| Model: Trimmer Unit TR5040 (D520) | Date: 14-Jul-11 | No.: RD520001 |

| Subject: Firmware Release Note: Trimmer Unit TR5040 |  | Prepared by: K.Tsutsui                               |  |

| Model: Trimmer Unit TR5020 (D455)       |   | Date: 22-Sept-11   | No.: RD455005  |
| Subject: Adjustment of the trim volume  |   | Prepared by: T. Komori   |  |

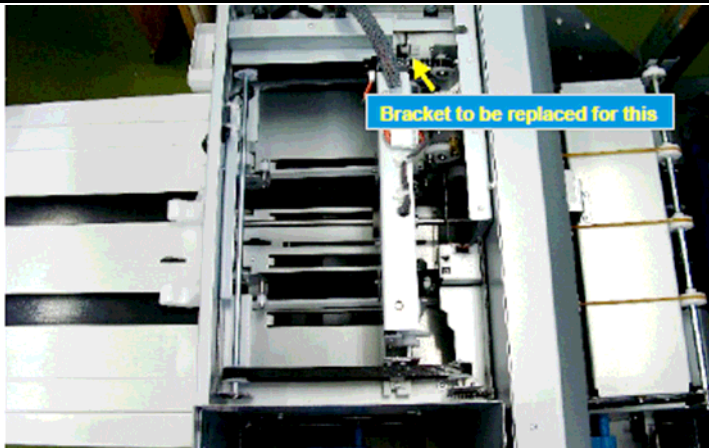
## NOTE

- The blade could be damaged if the trim volume is set too low.  
Please inform your customers that the adjustment on the operation panel must be made carefully to avoid poor cuts after replacing with the modified bracket.

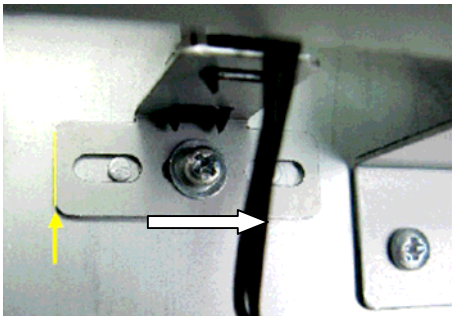
- Remove the covers as shown in the diagram.

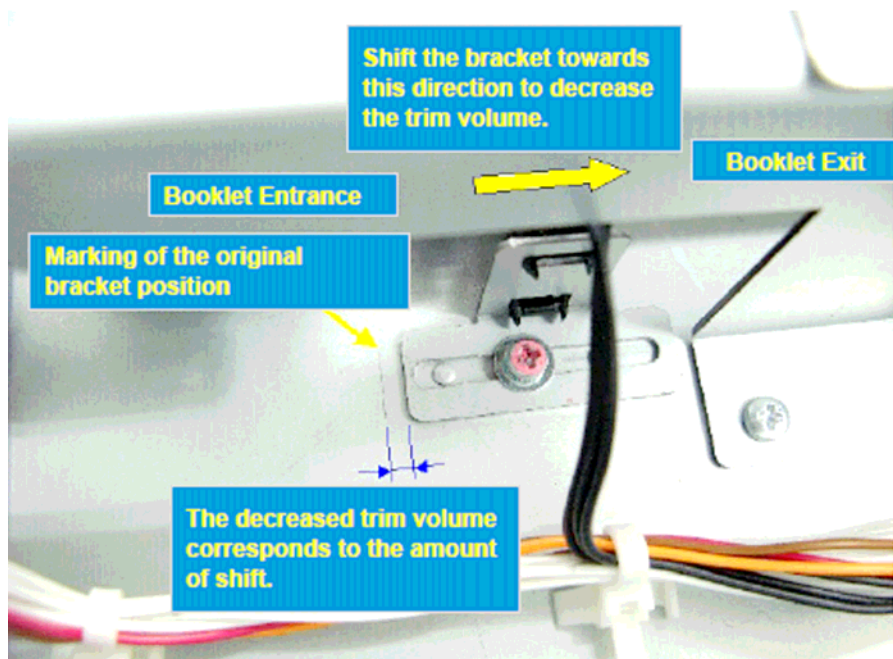
4. Move the bracket in the direction of the arrow (decrease in trim volume).  
Check the trim volume.

DO NOT shift the sensor bracket in the opposite direction (increase in trim volume) as this may cause damage to the machine due to interference with the registration unit.

5. Reassemble the unit when the desired volume is obtained. If not satisfy the customer's demand, please go method #2.

2. Details > Operation > Operation Flow > Limitless Output

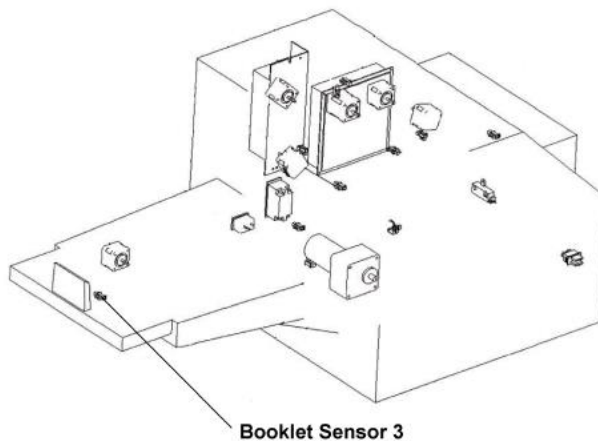
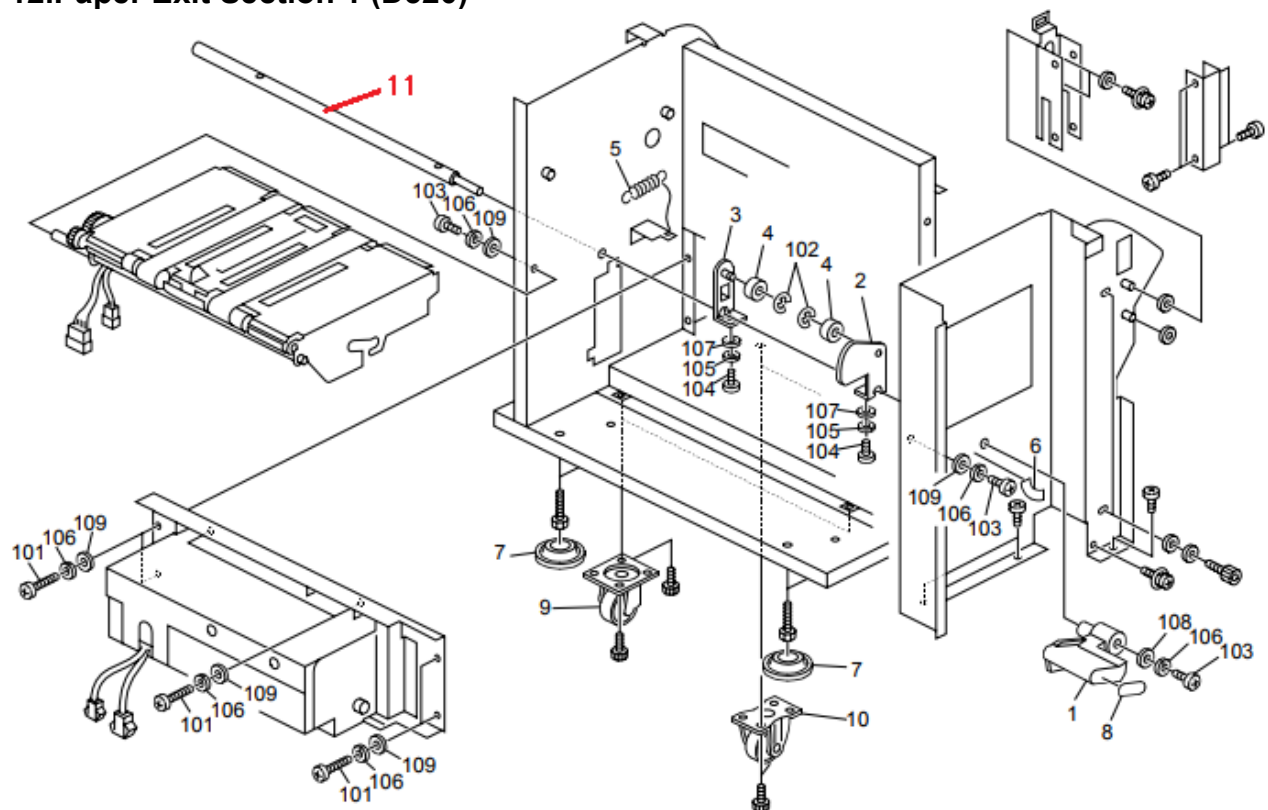
### Incorrect:

#### Limitless Output

The trimmer can be set up for limitless output.

1. First, remove the end stopper from the output tray.

2. Next, disable booklet sensor 3. This requires a service call by a trained service technician to disconnect the sensor.

- With booklet sensor 3 disabled, the trimmer will not detect tray full.
- The trimmer will operate continuously without interruption. The booklets will fall off the end of the tray into a container placed at the end of the tray.

**Correct:**

## Limitless Output

The trimmer can be set up for limitless output.

Remove the end stopper from the output tray. This will automatically disable the output tray full sensor (Booklet Sensor 3) and enable "Limitless Output."

### 3.Paper Feed Unit 2 (D520)

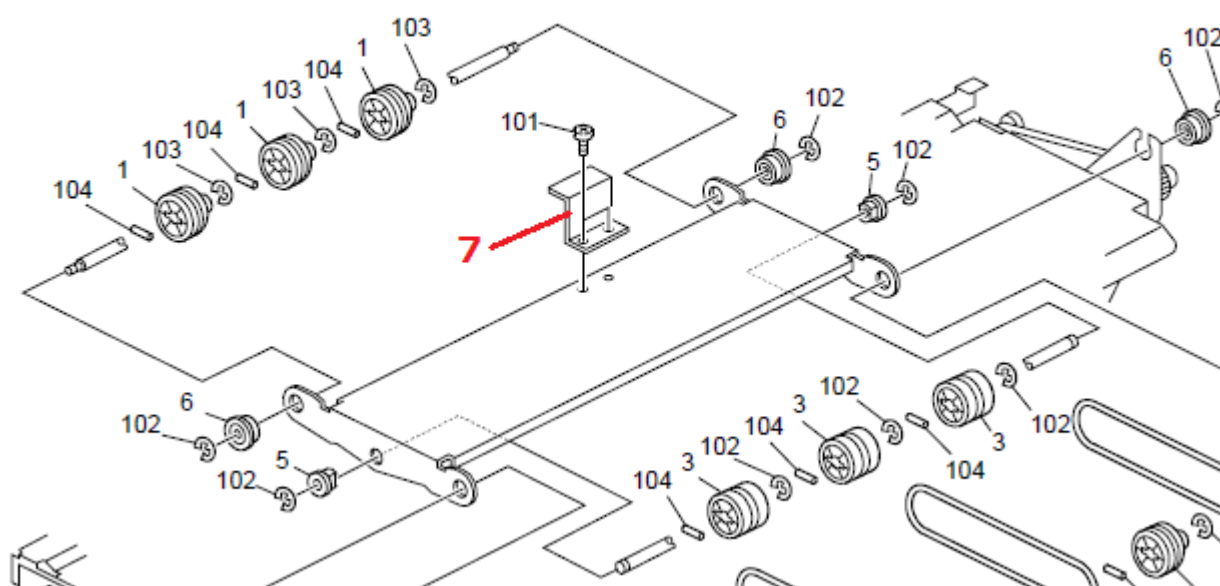
The following part are registered as new service parts to meet requests received from the field.

| Old part number | New part number | Description                   | Q'ty | Int | Page | Index | Note |
|-----------------|-----------------|-------------------------------|------|-----|------|-------|------|
| -               | D4551176        | STOPPER:ENTRANCE:YZ4-08405302 | 1    | -   | 7    | 7     | Add  |

| Subject: Parts information - Paper Exit Section        |   | Prepared by: S.Tomoe   |  |

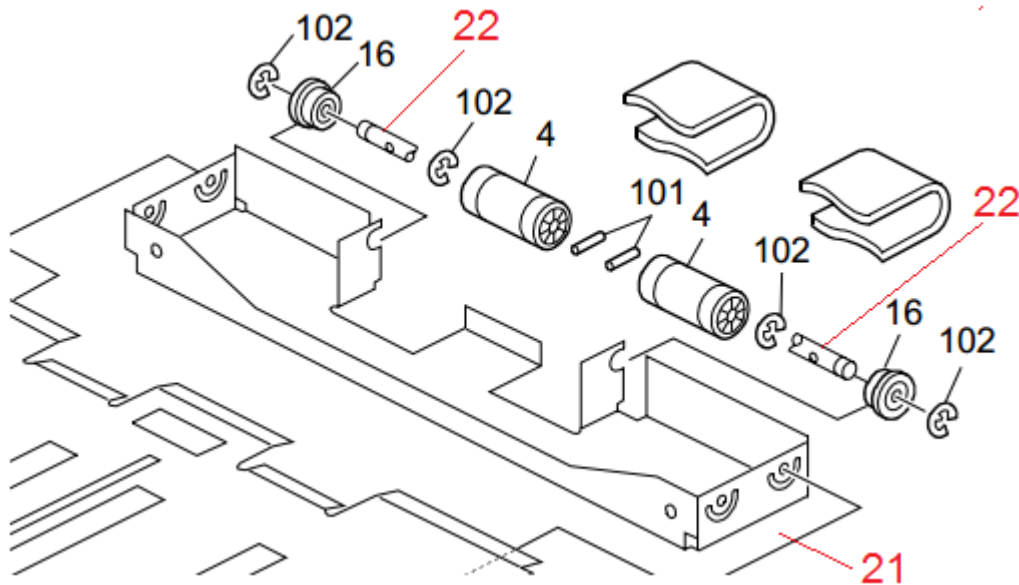
The following part are registered as new service parts to meet requests received from the field.

| Old part number | New part number | Description                    | Q'ty | Int | Page | Index | Note |
|-----------------|-----------------|--------------------------------|------|-----|------|-------|------|
| -               | D4551272        | BRACKET:FRONT:YZ3-08407005     | 1    | -   | 27   | 21    | Add  |
| -               | D4551278        | SHAFT:ROLLER:FRONT:Z4-08407008 | 1    | -   | 27   | 22    | Add  |
